HOLDOVER
REVISED
DAWES LAKE TRACE SUBDIVISION

APPLICATION NUMBER Holdover DATE May 6, 2004

SUBDIVISION PLAN

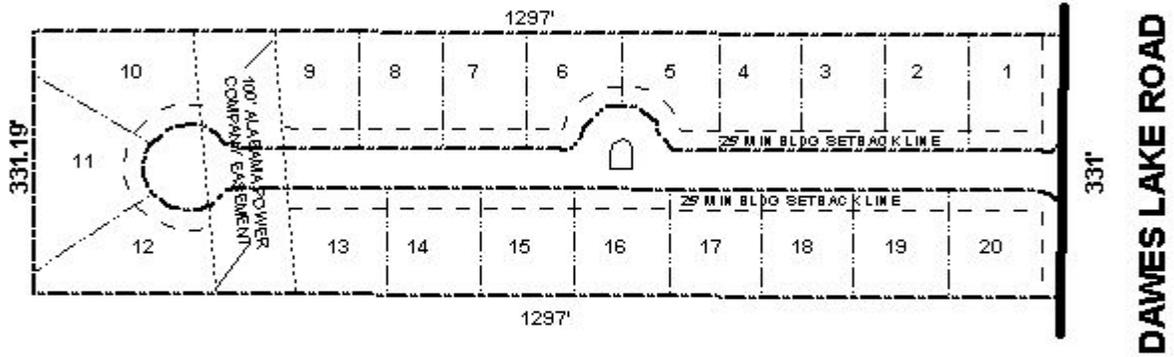
As proposed, Lots 1 and 20 would have frontage along Dawes Lake Road and the new street; therefore, the placement of a note on the final plat stating the Lots 1 and 20 are denied direct access to Dawes Lake Road, should be required.

The Subdivision Regulations state that a closed end street shall not be longer than 600'. Section V.B.1 also states that street stubs shall be provided to large undeveloped tracts of land. As proposed, the closed end street is approximately 1,297' long; therefore, a street stub to the North, between Lots 4-7, should be required. It should be noted that the large parcel to the North is undeveloped and does not have enough road frontage to allow the construction of a road. A similar subdivision was approved South of this site (Vintage Woods Subdivision) in 1988. The difference between this application and Vintage Woods is that Vintage Woods was not adjacent to a large undeveloped tract of land.

It should be noted that the applicant is providing a traffic calming device. The traffic calming device is not labeled as common area and thus should be labeled as such. In addition, the placement of a note on the final plat stating that the common area is the responsibility of the property owners, should be required.

This site is located in the County, thus a note should be placed on the final plat stating that any lots which are developed commercially, and adjoin residentially developed property, must provide a buffer, in compliance with Section V.A.7. of the Subdivision Regulations.

This application was held over for the May 6th meeting at the applicant's request. It should be noted that the application mistakenly stated that sanitary sewer would service the site; however, public water and individual septic systems will serve the site. The lots as proposed comply with the minimum lot size (15,000 square feet) requirements of the Subdivision Regulations. The plat

meets the minimum requirement of the Subdivision Regulations and is recommended for Tentative Approval subject to the following conditions: 1) the placement of a note on the final plat stating the Lots 1 and 20 are denied direct access to Dawes Lake Road; 2) the provision of a street stub to the North located between Lots 4-7; 3) location and design of the traffic calming device to be approved by County Engineering; 4) the traffic calming device be labeled as common area with a note placed on the plat stating that the maintenance of the common area is the responsibility of the property owners; and 5) the placement of a note on the final plat stating that if any property is developed commercially and adjoins residential property, a buffer in compliance with Section V.A.7. of the Subdivision Regulations, will be provided.
